Type 310A

PRODUCT MODIFICATION INDEX

IMPROVES LF TRIGGERING

COMPONENTS CHANGED TO
PREVENT FREE-RUNNING

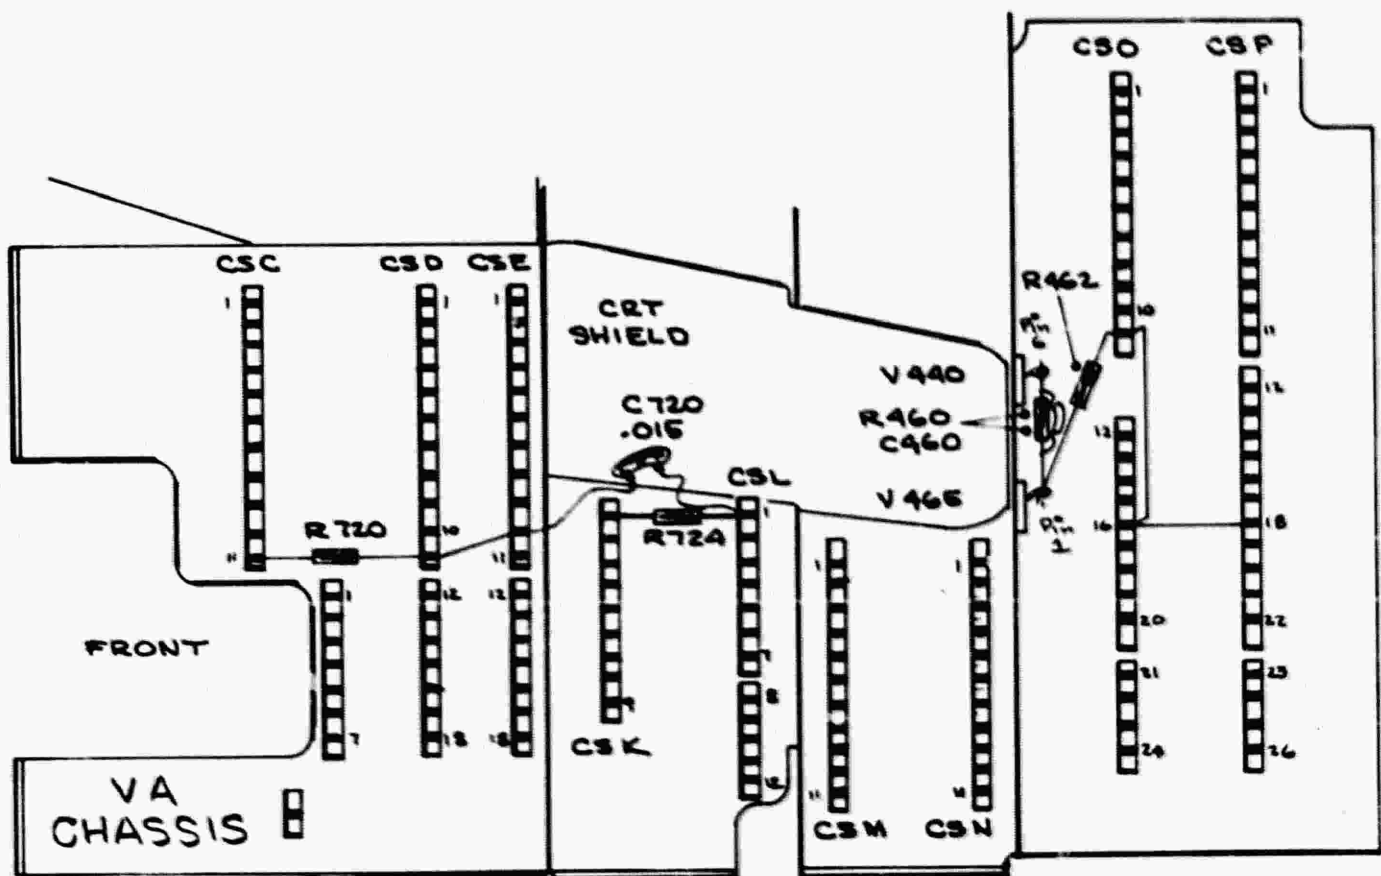
Components are changed and relocated to prevent free-running of the sweep when set for AUTO and +INT TRIGGER MODE, at sweep speeds of 20 μ sec/cm or faster, 'Variable' uncalibrated, and utilizing low amplitude signals at 50 cycles. Free-running was caused by loading of the sweep multi by the unblanking circuit, and by the unblanking pulse being picked up by the trigger pickoff CF (V465).

- 1) Locate R720, a 15k resistor, located between CSC-11 and CSD-11. If it is a 15k resistor, replace it with a 68k 1/2W 10% resistor.
 - 2) Replace C720, located between CSE-10 and CSL-1, with a 0.015 μ F 2.5kV discap.
- STEP 3 APPLIES ONLY TO SN 10001-11669.
- 3) Replace R724, a 1.5M 1/2W resistor, connected between CSK-1 and CSL-1 with a 2.2M 1/2W resistor.
 - 4) Relocate one end of the parallel combination of R460 (183k) and C460 (1.5pF) from CSO-11 to pin 6 of V440.

- 5) Remove the bare wire between pin 6 of V440 and CS0-11.
- 6) Relocate R462 (143k 1% resistor) from between CS0-15 and CSP-18, to between pin 1 of V465 and CS0-11 (dress under R460).
- 7) Remove the bare wire between pin 1 of V465 and CS0-16.
- 8) Install bare wire from CS0-16 to CSP-18.
- 9) Install bare wire from CS0-16 to CS0-11.

Parts Added:

C720	283-0030-00	Capacitor, 0.015 μ F 2.5kV
R720	302-0683-00	Resistor, 68k 1/2W 10%

D150 ADDED TO REDUCE
SELECTION OF V150

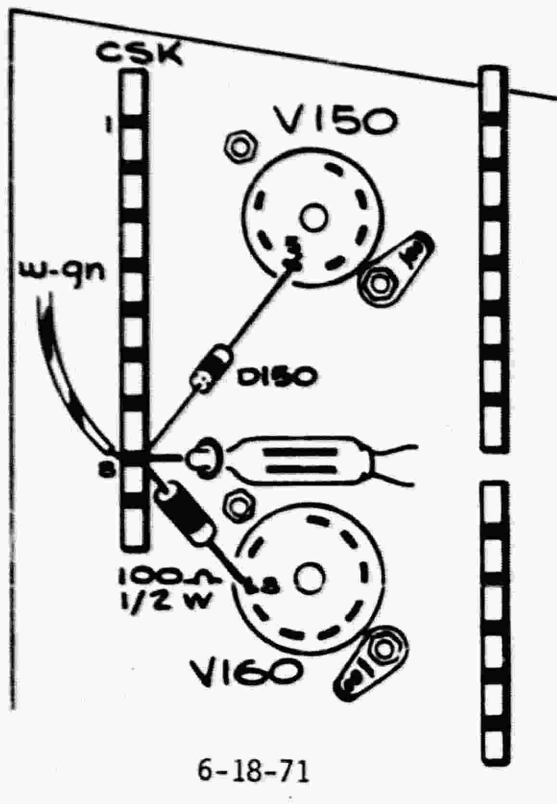
Excessive leakage of the Miller disconnect diode was causing slow speed timing error and fast sweep speed jitter. A low leakage semiconductor diode was added in series with the Miller tube control grid disconnect diode. This combines the low leakage characteristic of the semiconductor with the fast turn-off capability of the vacuum diode.

- 1) Relocate the 100Ω resistor (R170) lead and the white-green wire from pin 5 of V150 to CSK-8 (see drawing). Splice extra wire onto the white-green wire if necessary.
- 2) Add diode D150 between CSK-8 (banded end) and pin 5 of V150.

3-WIRE POWER CORD FEMALE GROUND CONNECTION IMPROVEMENT

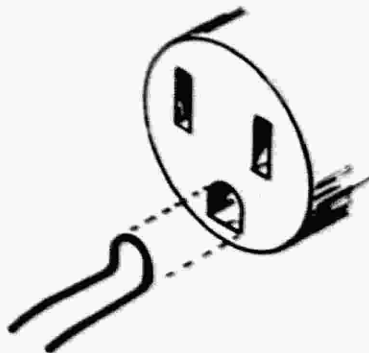
Modification Kit, PN 040-0424-01, improves the non-current carrying ground contact on the 3-wire power cords, used on TEKTRONIX Type instruments, by adding a spring to the female contact.

- () Insert the spring (from kit) as indicated in the drawing below, and push it in by plugging the male end of the power cord into the female end.

CRT REPLACEMENT

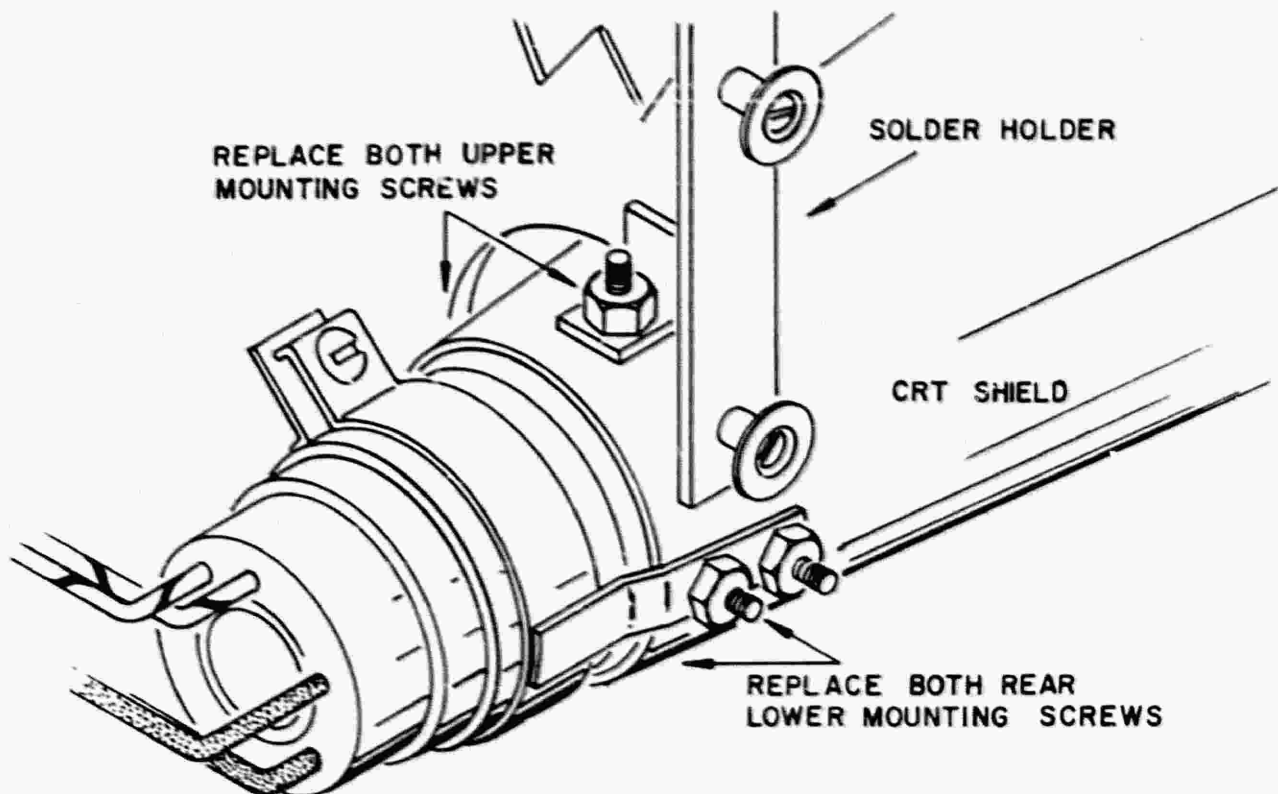
The Type T3100 ___ CRT replaces the Type 3WP ___ CRT. Replacement of the CRT socket by a 136-0081-00 socket is required to install the new CRT. Four of the binding head screws used in the Type 315D CRT shield are replaced with flat head screws to allow clearance for the new T3100 ___ CRTs.

- () 1. Remove the cathode ray tube (CRT).
- () 2. Remove the HV shield (337-0016-00) from the top rear, left side of the instrument.
- () 3. Remove the DC Shift Comp bracket over the rear of the CRT shield.
- () NOTE: Position the bracket up and toward the opposite side of the instrument.
- () 4. Unsolder the CRT socket leads, noting their locations in respect to color-code.
- () 5. Replace the four CRT shield mounting screws, indicated in the drawing, with the four flat head screws from the kit.
- () 6. Cut the leads of the new socket to match those on the old socket.
NOTE: The new socket has a white-red lead in place of one of the two brown filament leads on the old socket.
- () 7. Install the new CRT socket in the instrument.
- () 8. Replace the DC Shift Comp bracket and HV shield previously removed.
- () 9. Install the CRT.

CRT CIRCUIT
(partial)

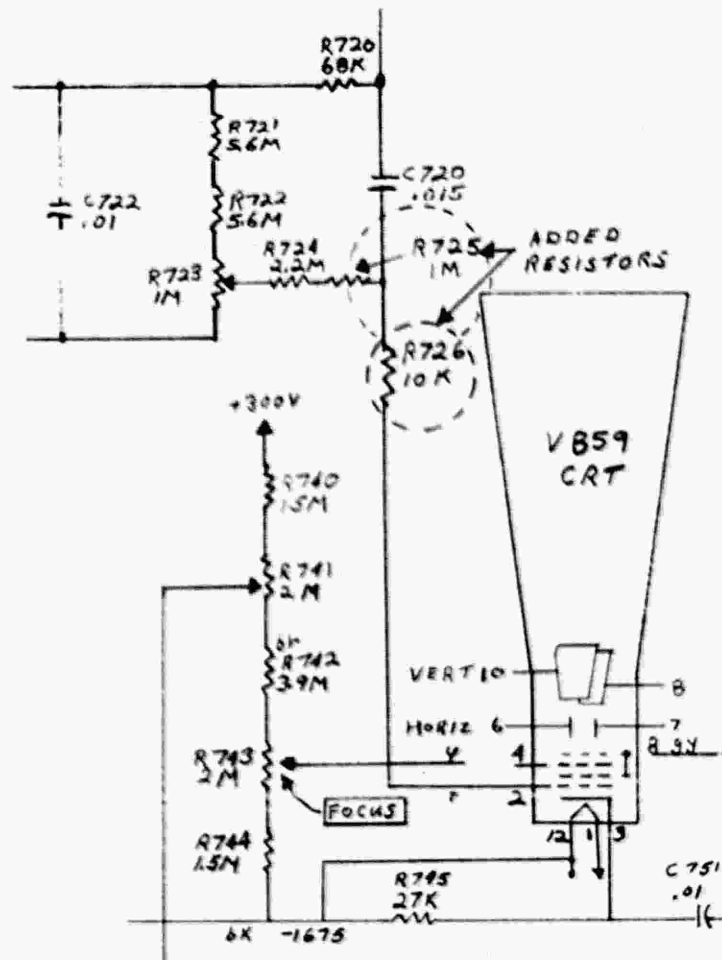
Poor unblanking on 1ms-500 μ s sweep speeds. Free run rate or frequency is changed on AUTO INT position with no signal in, AUTO tried to run at sweep rate. Absolute value of C720 is only approximately 0.002 μ F to 0.003 μ F at 2kV. This allows one or two time constants to overshoot, causing unblanking bright spot. Auto Multi picks up radiation from CRT grid line and lead to INT potentiometer through internal trigger pickoff lead. C720 was changed from 283-0030-00 to 283-0042-00, plus the addition of a 10k 1/4W 5% and 1M 1/2W 10% resistors. See schematic for changes and additions.

Layout changes are necessary to keep voltage differences on adjacent ceramic strip terminals to less than 2kV. Shield has to be trimmed slightly.

C720	283-0042-00	Capacitor, 0.015 μ F 3kV
R725	302-0105-00	Resistor, 1M 1/2W 10%
R726	315-0103-00	Resistor, 10k 1/4W 5%
	179-0291-01	Cable, VA #1
	337-0267-01	Shield, sweep generator

FIG. 1

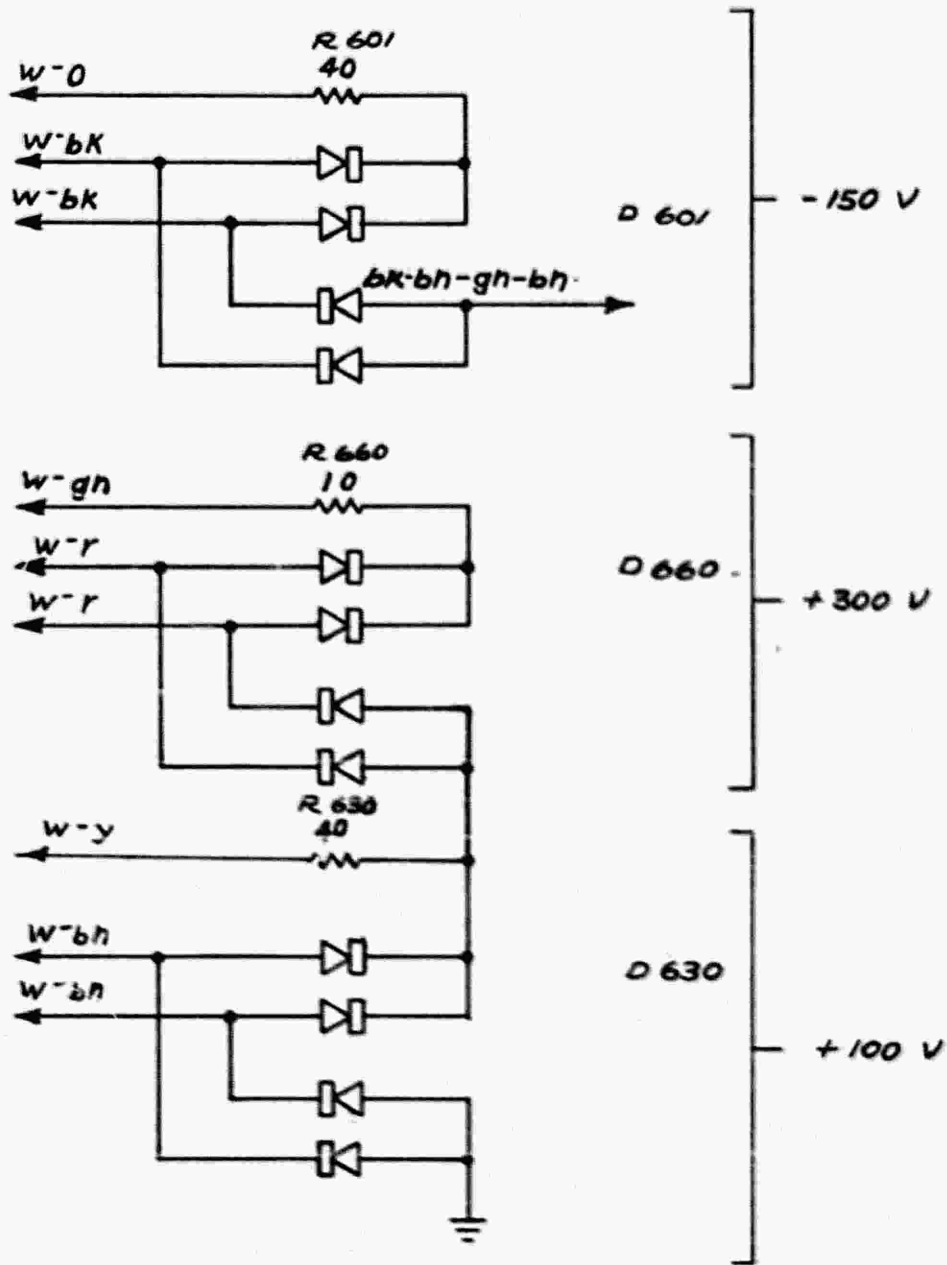
Modification Kit, PN 040-0195-00 provides parts and instructions to replace selenium rectifiers, PN 106-0020-00 or PN 106-0032-00 (SR601 and SR660), and selenium rectifier PN 106-0033-00 (SR630) with silicon rectifiers, offering more reliability and longer life.

The installation involves adding three resistors (R601, R630 and R660), to compensate for the lower voltage drop across the silicon diodes. The resistors, and diodes are mounted on a bracket.

- () 1. Remove the four rectifier bracket screws.
- () 2. Position the rectifier bracket back and unsolder all lead connections to the selenium rectifiers and the thermal cut-out disc.

- () 3. Remove the rectifier bracket assembly.
- () 4. Drill a 3/16 inch hole, 11/16 inch below the R668 mounting nut.
- () 5. Remove R608 from the rectifier bracket assembly and mount it, using the hole just drilled. Align the terminals in the same direction as R668 and leave the ground lug connected to the bottom terminal.

FIG. 2

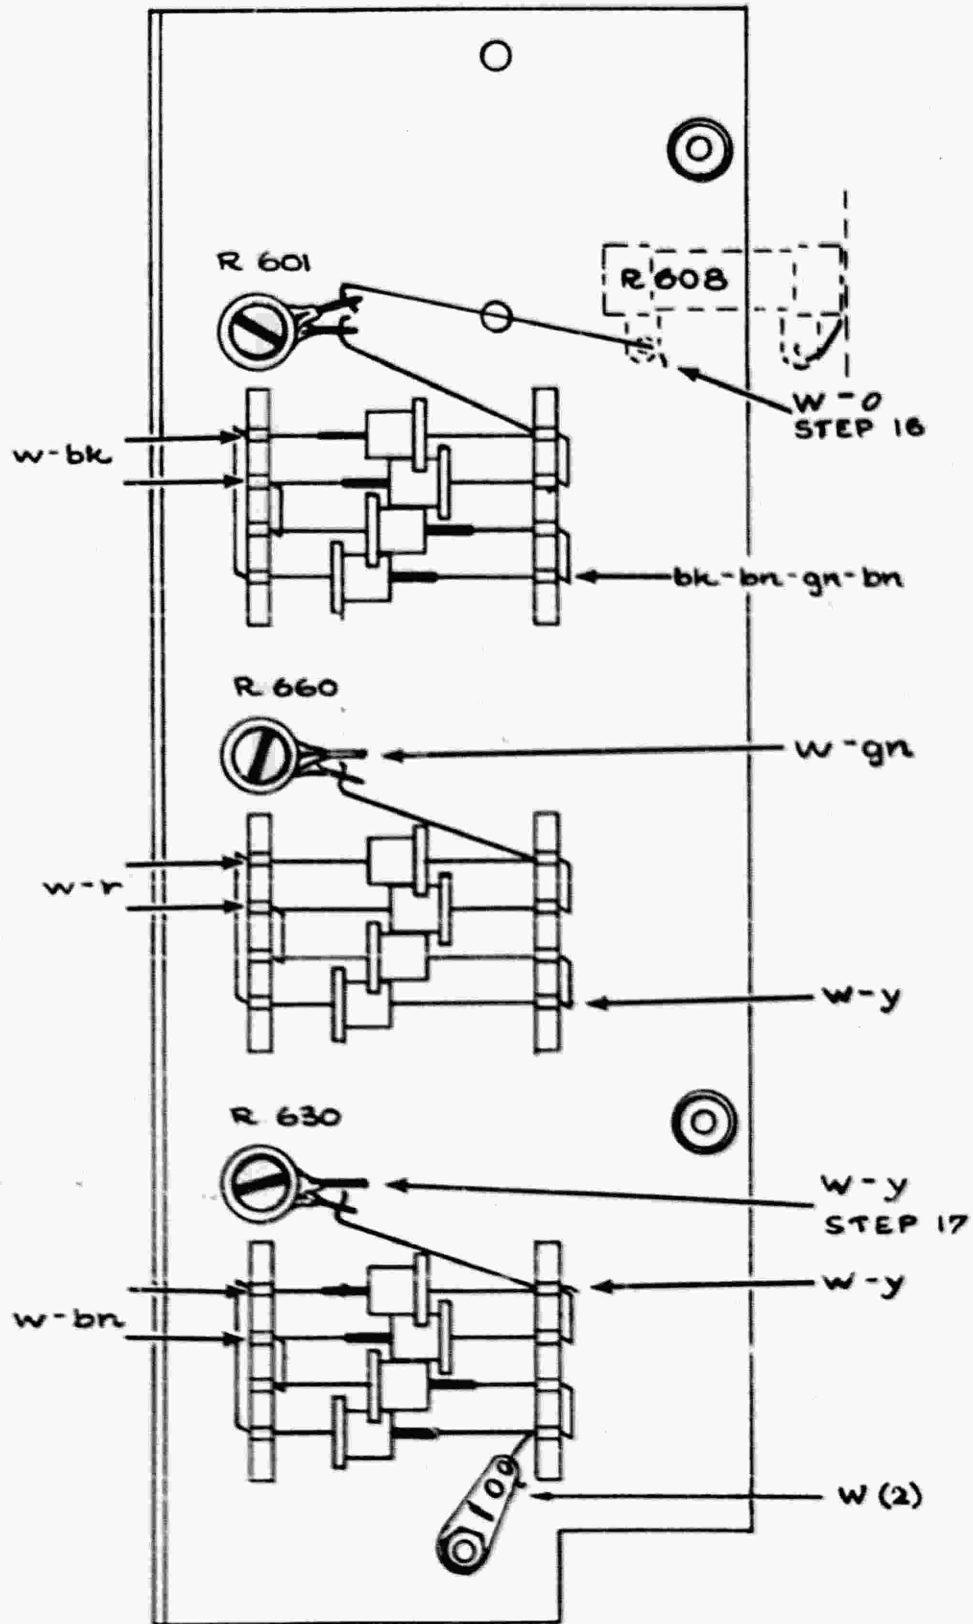
- () 11. Remove the two thermal cut-out mounting screws, the four rectifier bracket mounting screws, and the selenium rectifier mounting nuts located on the inside of the chassis.
- () 12. Unsolder the leads to the selenium rectifiers and remove the rectifiers from the chassis.
- () 13. Remove the old rectifier bracket and mount the new silicon rectifier bracket (from kit) in its place.
- () 14. Mount the thermal cut-out on the new bracket.

- () 15. Solder two yellow-brown-brown-brown wires to the thermal cut-out.
- () 16. Solder the white-orange wire from C601, and the strap from R601, to R608 (see Fig. 2, step 16).
- () 17. Solder the white-yellow wire from C660 to the top terminal of R630 (see Fig. 2, step 17).
- () 18. Solder the remaining wires to the points indicated in Fig. 2.
- () 19. Reinstall V520, V602, V613, V631 and V661 (if removed in step 3).

LOW VOLTAGE POWER SUPPLY
(Partial Daigram)

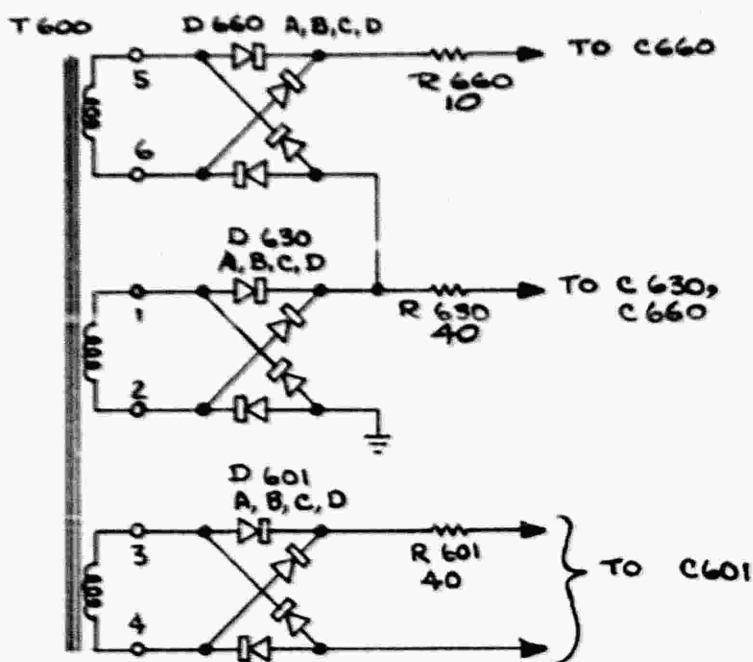
Modification Kit, PN 040-0195-00, provided parts and instructions to replace selenium rectifiers, PN 106-0020-00 or PN 106-0032-00 (SR601 and SR660), and selenium rectifier PN 106-0033-00 (SR630) with silicon rectifiers, offering more reliability and longer life.

Ckt.No.	Part Number	Description
DIODES		
D601A,B,C,D	152-0066-00	500-750mA 400PIV Silicon
D630A,B,C,D	152-0066-00	500-750mA 400PIV Silicon
D660A,B,C,D	152-0066-00	500-750mA 400PIV Silicon
RESISTORS		
R601	308-0012-00	40Ω 10W WW 5%
R630	308-0012-00	40Ω 10W WW 5%
R660	308-0175-00	10Ω 10W WW 5%
